Question regarding plumbing plans:

ROXUL USA INC.
 ROCKWOOL WASTEWATER TREATMENT PLANT
 CONCEPTUAL LAYOUT
 JEFFERSON COUNTY, WEST VIRGINIA
 SANITARY SEWER LAYOUT

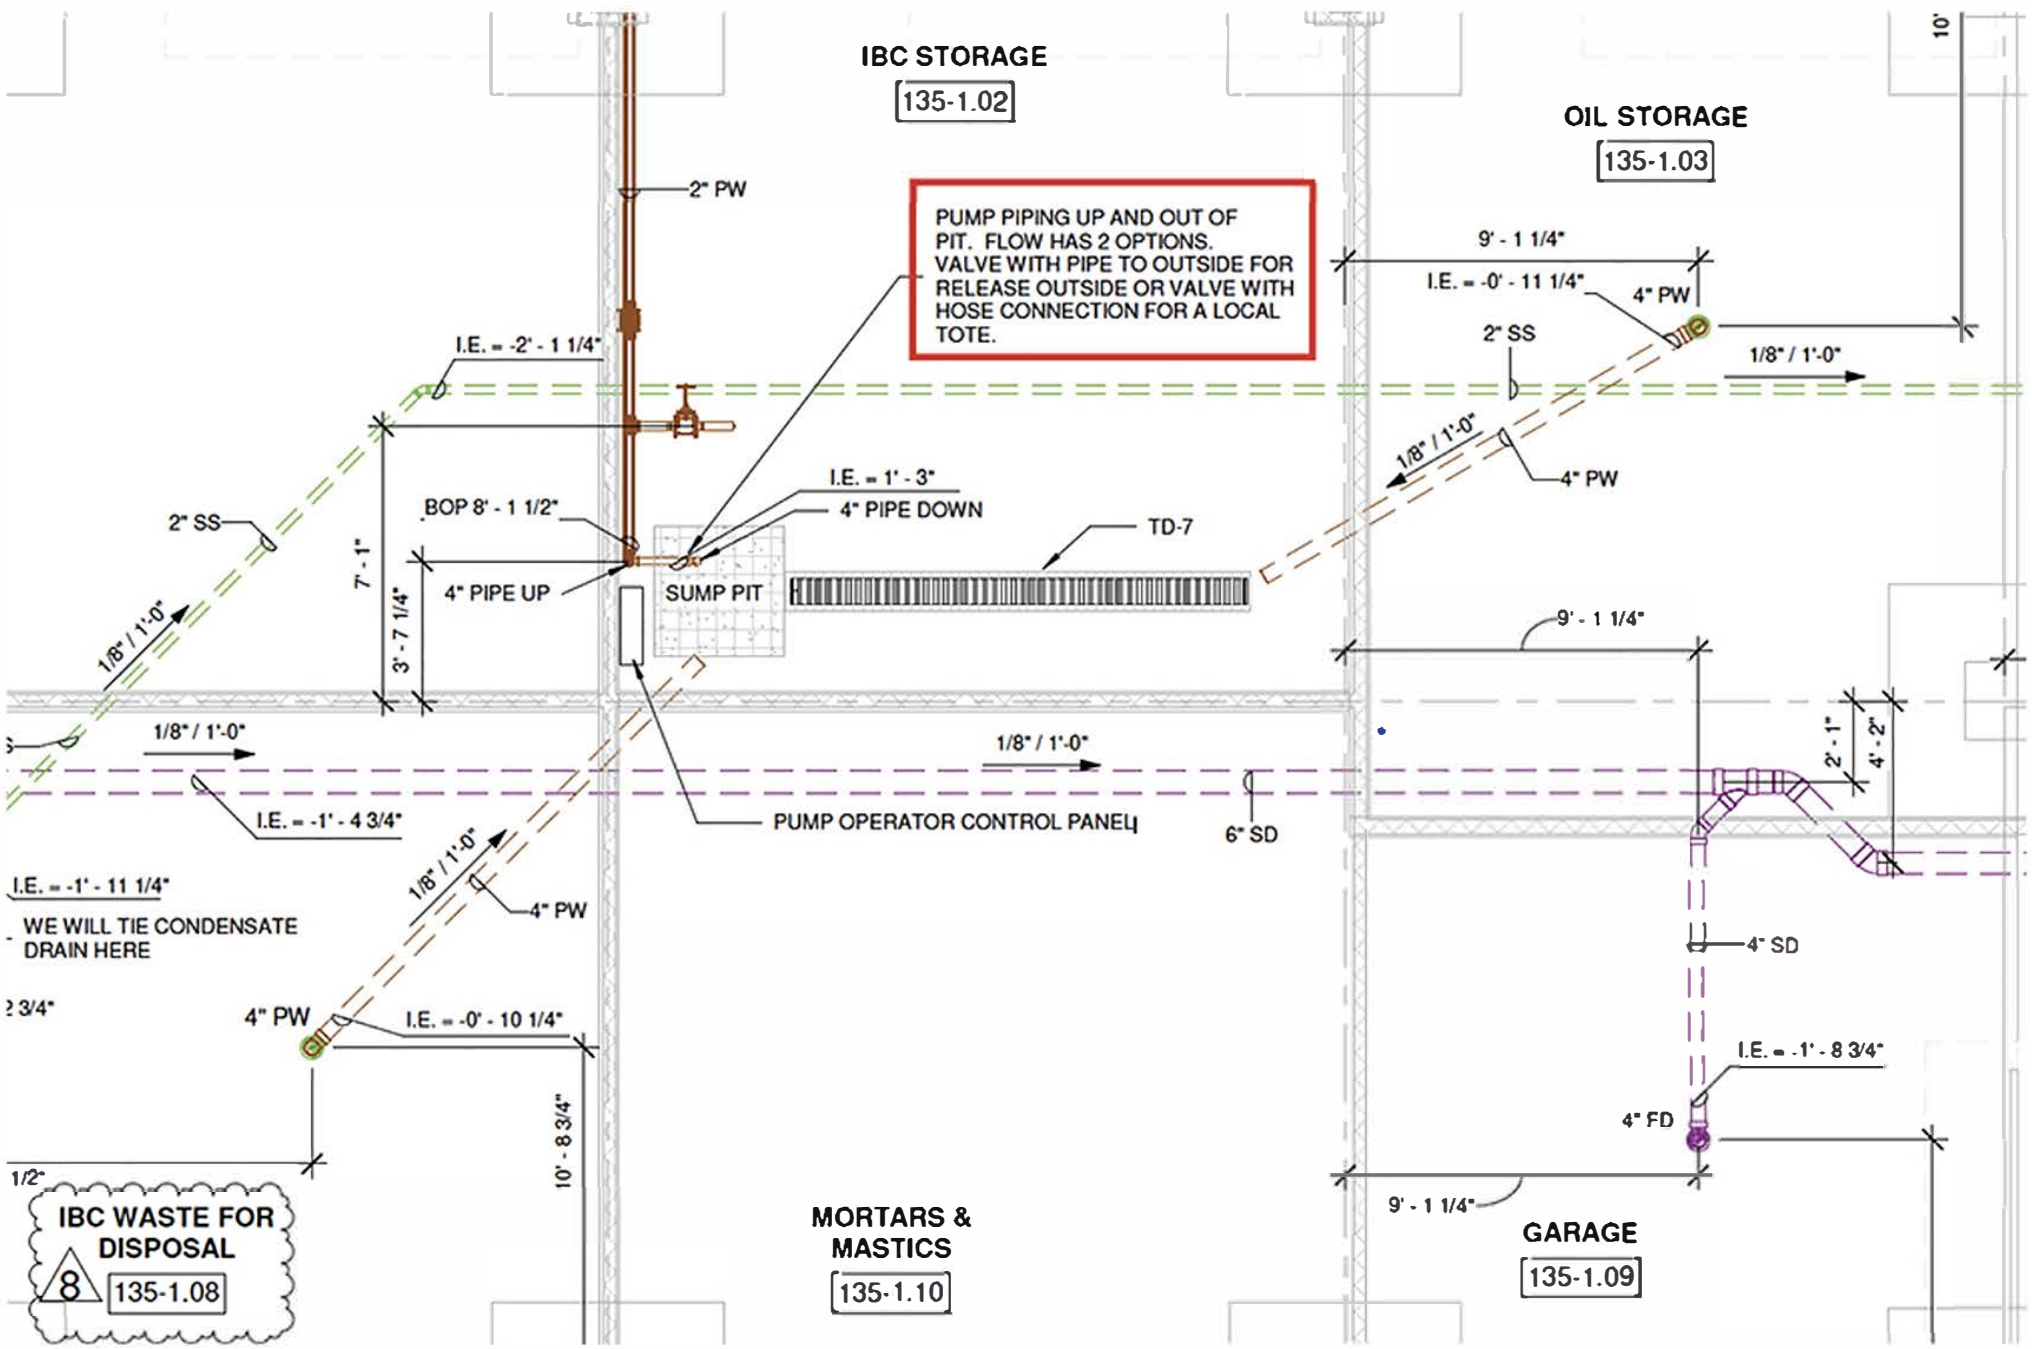
On Sheet no. PA0201.2, there is a sump pit with a pipe in it labeled, "Pump piping up and out of pit. Flow has 2 options. Valve with pipe to outside for release outside or valve with hose connection for local tote." This is a modification in the 12-2019 plans from previous plans.

In the reply from Thrasher Engineering to Mr. Eckenrode's questions about this particular feature (question and response 8), Mr. Ferrell said, "For ease of construction, water from this sump will be tied into process water system. For clarification, there are no sumps connected into the sewer system. Further clarification can be provided that as per the note indicated on PA021.2 [sic] that these sumps are monitored and controlled by plant operator. If the plant operator determines there will be no negative impact, the sump discharge will enter the storm system. This will only occur after the plant's operator evaluates the discharge."

We cannot see where this sump pit ties into the process water line. Where does it tie into the process water line? By what methods does the "operator" determine there will be "no negative impact"? If it is determined the contents will have a negative impact and they need to be diverted to the local tote, where will the contents of the local tote be discharged?

SHEET NO.
PG0211

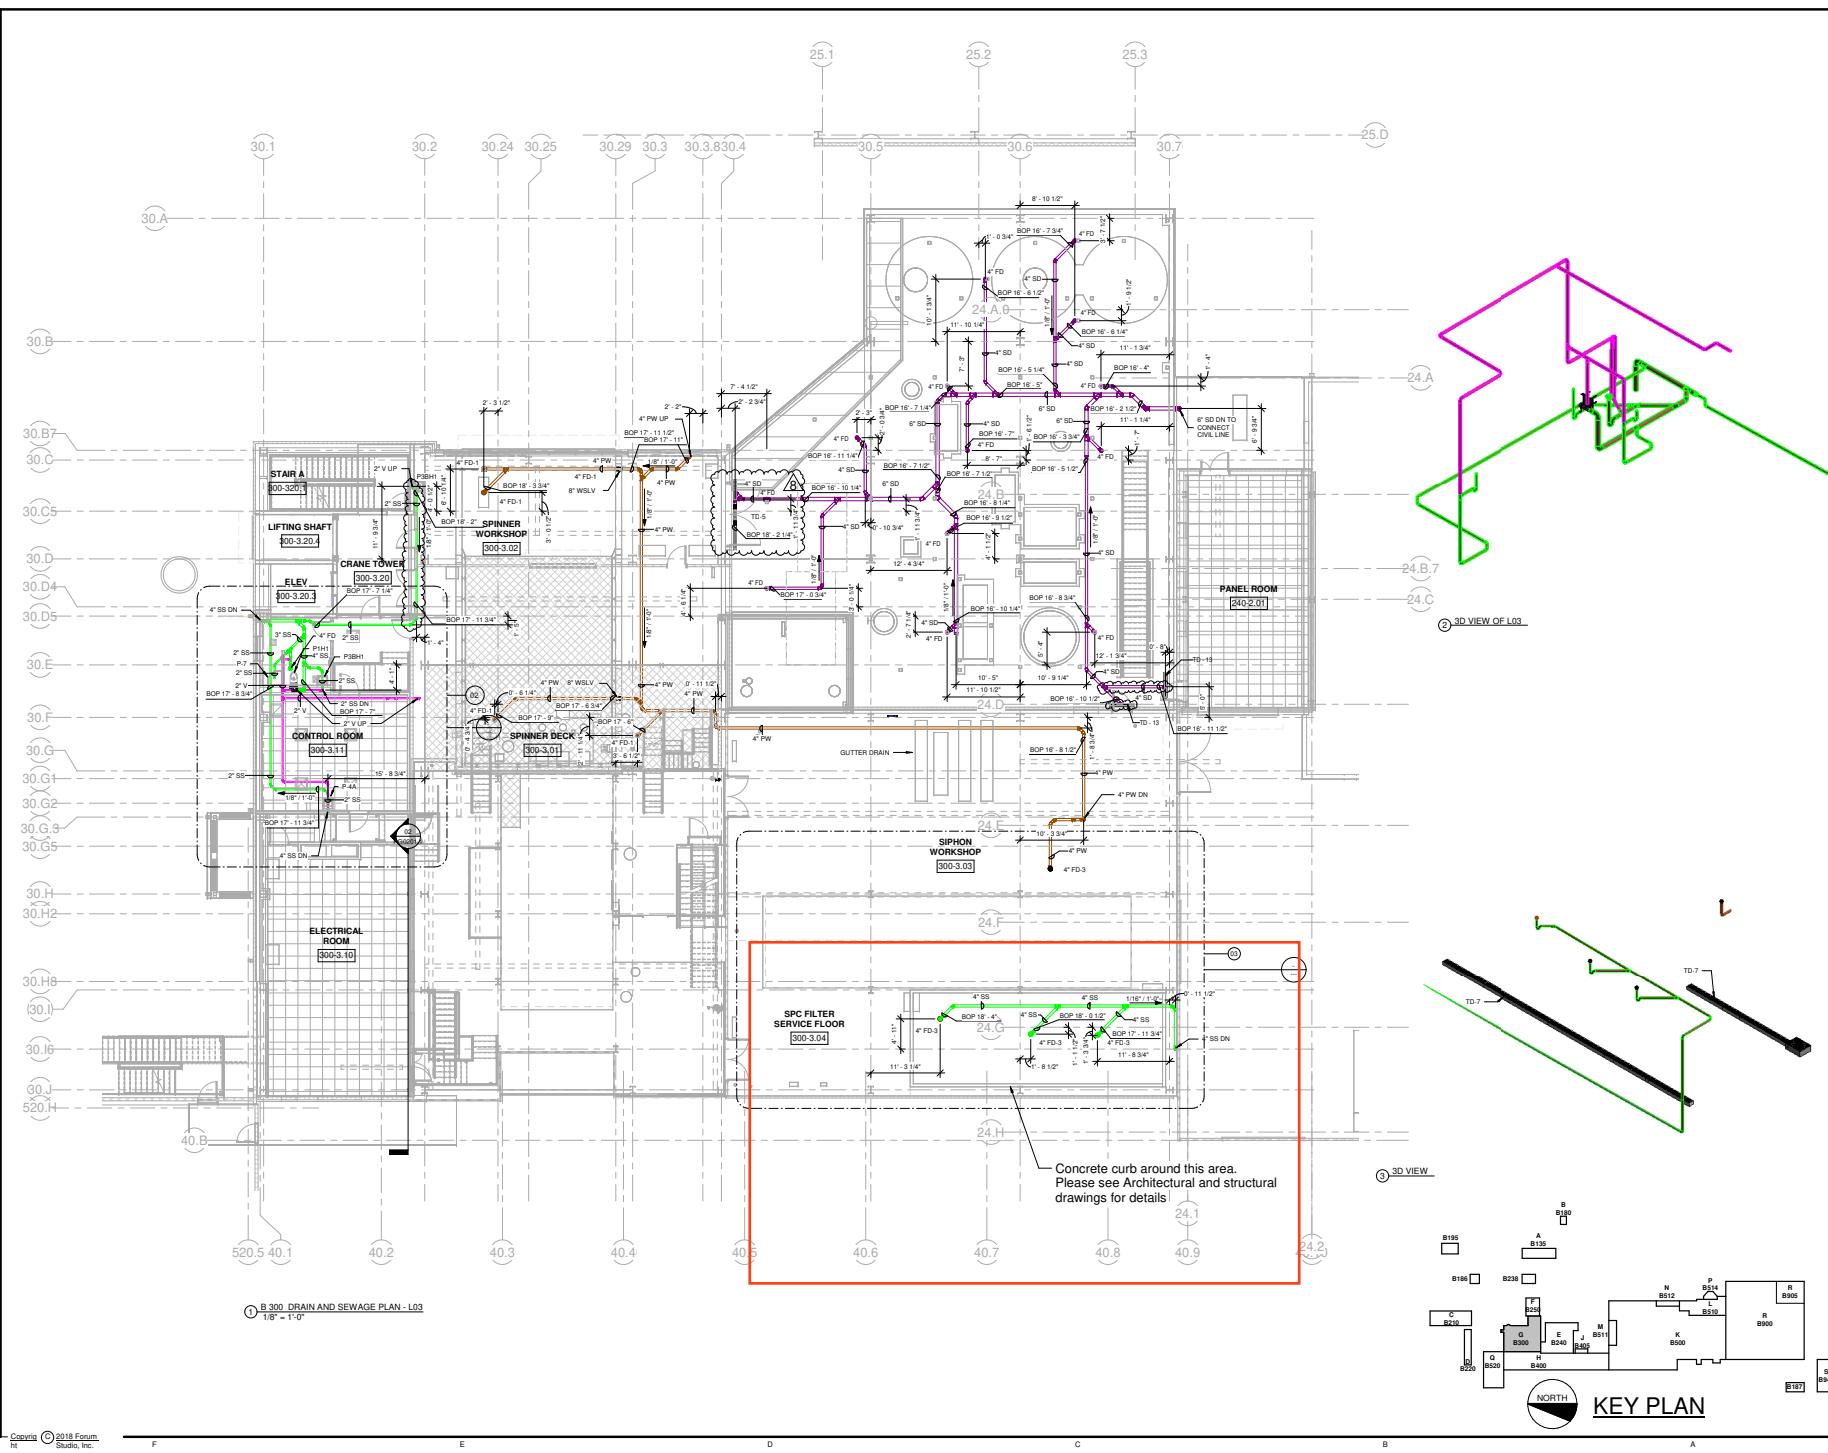
On Sheet No. PG0211 there are three floor drains that are shown emptying into the sanitary sewer from building 300 in the SPC filter Service Floor. What is the purpose of these floor drains? What activities will happen in the area that will be drained to these drains? What surrounding areas will happen in the surrounding areas? Is this an area where people are able to walk in? If so what is the protocol to prevent contaminants from the remainder of the process floor from contaminating this area. We see the denotation of "Concrete curb around this area. Please see Architectural and structural drawings for details". However you have not made these available. Please share these with us and show us how these drains will be protected from contaminated material draining into them. Question 18 from Mr. Eckenrode asks

"Please confirm that no insulation or fiberglass products can enter the sanitary sewer system."

The response by Mr. Ferrell was:

"This letter confirms that no insulation or fiberglass products can enter the sewer system."

Please show what mechanisms are being employed and how these open floor drains are protected from fugitive contaminants in this process area.

SHEET No.
000-035

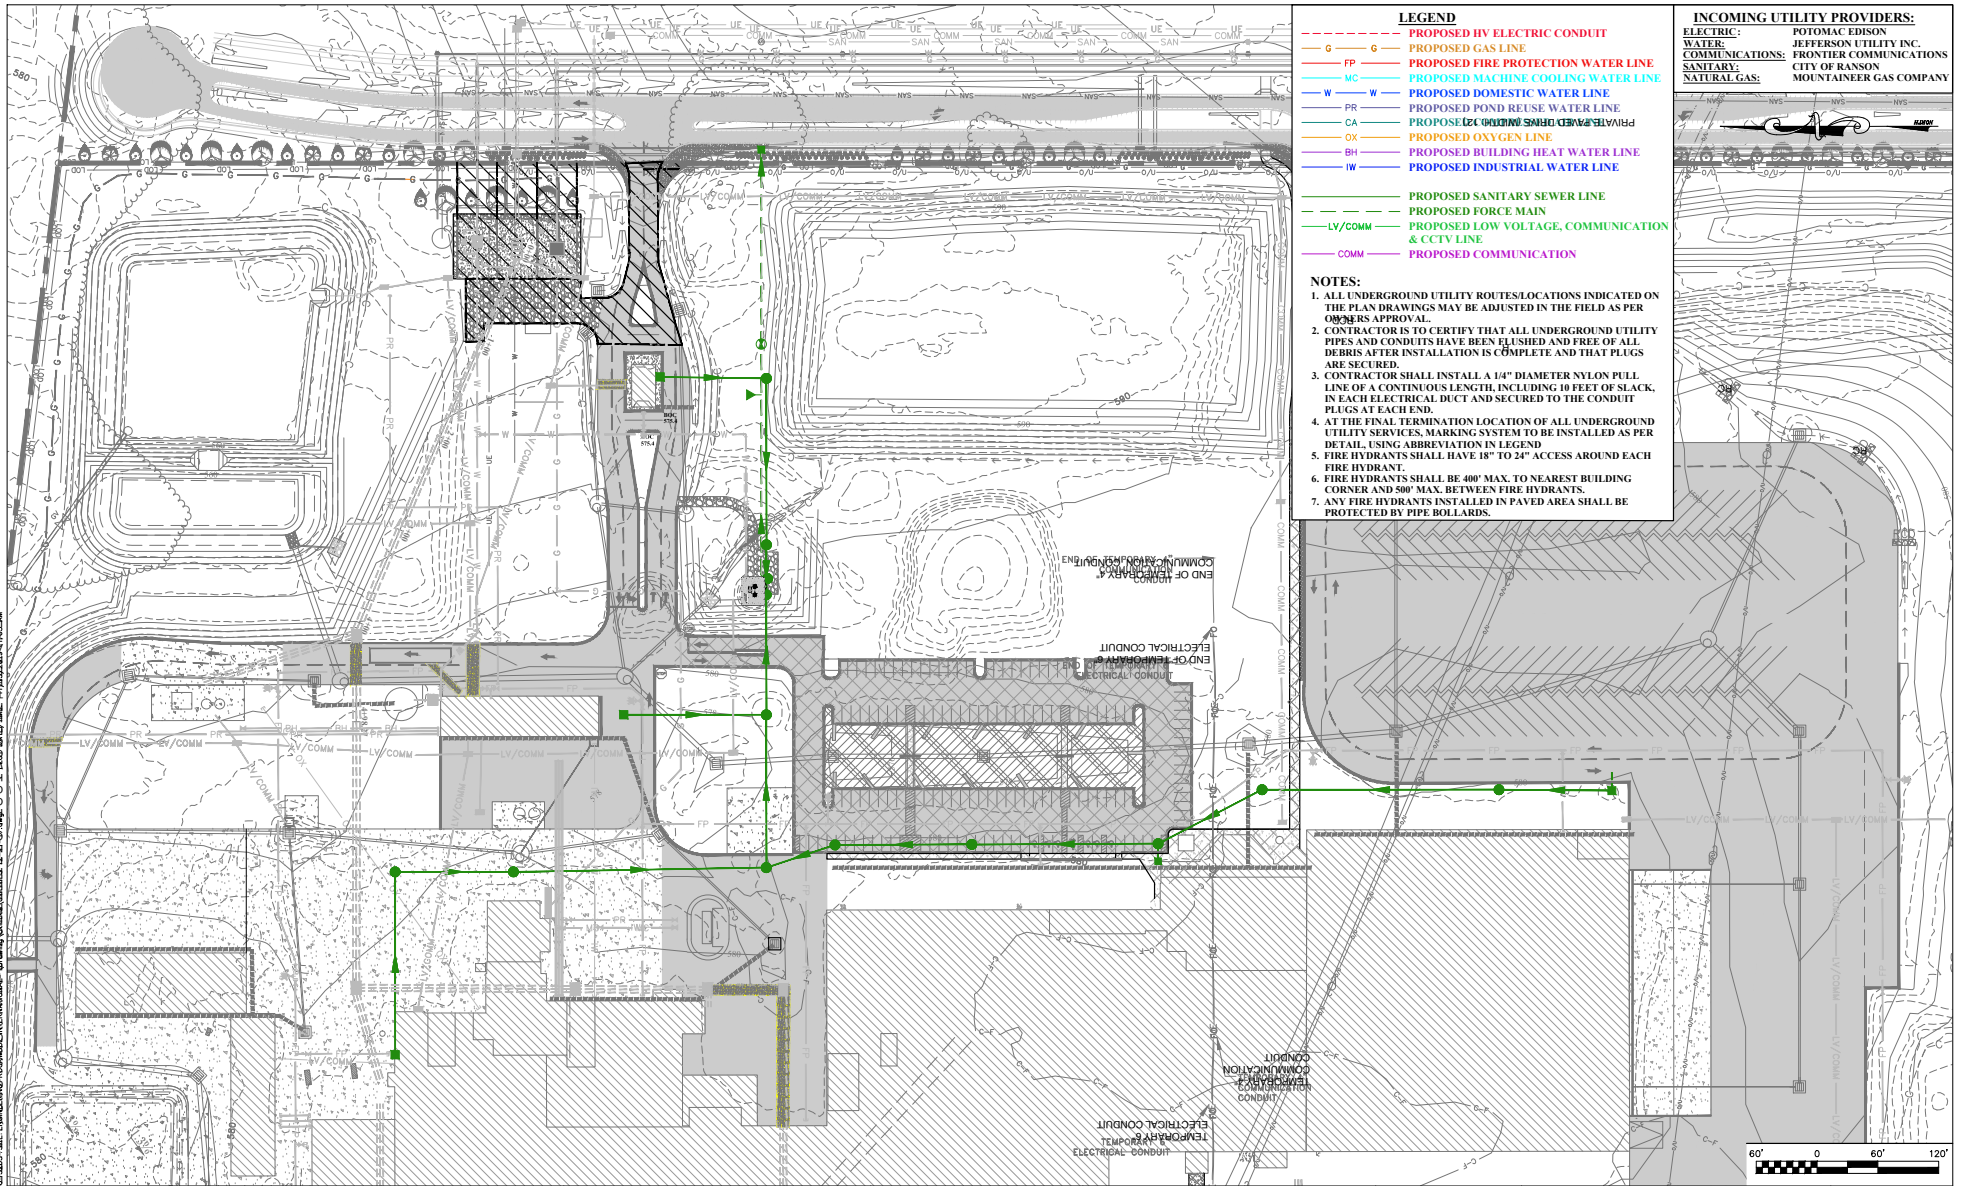
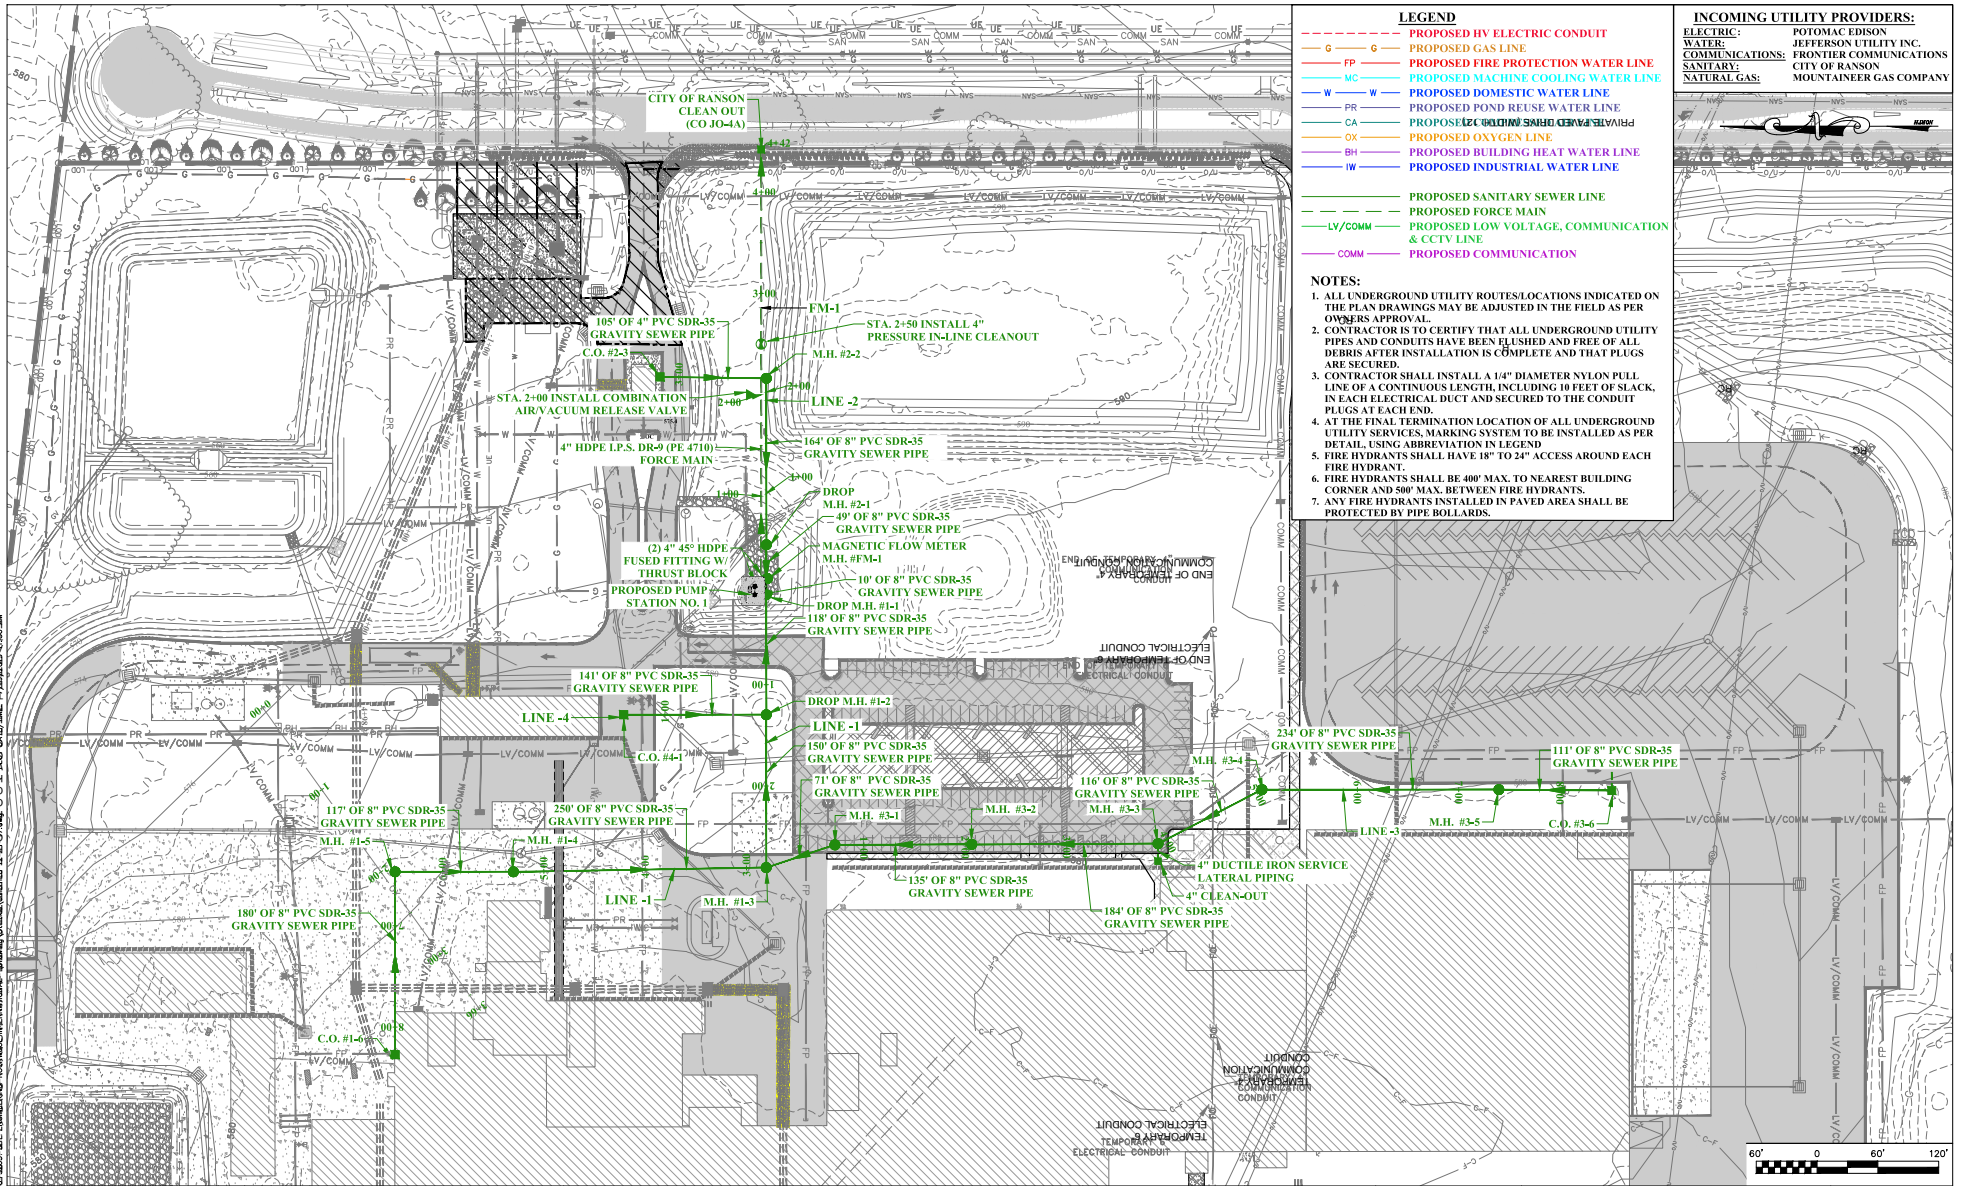
Will this be the same for the sampling well? On Sheet No. 000-035, there is no sampling well denoted. Where is the sampling well? Why does it not appear on the plans? How will the samples be taken? Who will be taking the samples and who will this person or persons be employed by?

There are requirements in the CTUB NPDES modification for sampling. Please explain and show where and how these will be accomplished.

We have reviewed the plans and we do not see the industrial sewer denoted anywhere. Specifically we do not see the industrial sewer line coming from Rockwool to connect to CTUB on 000-035. We understand that the industrial effluent is permitted to contain RO reject water and waister water from the water softener. We do not see either of these processes or lines denoted on any of the plans we have access to. Why was this not provided? Where is this industrial sewer line? Where and how and by whom will it be sampled? There is specific sampling set out in the CTUB NPDES permit for the industrial sewer line. Please explain specifically how this sampling will be accomplished.
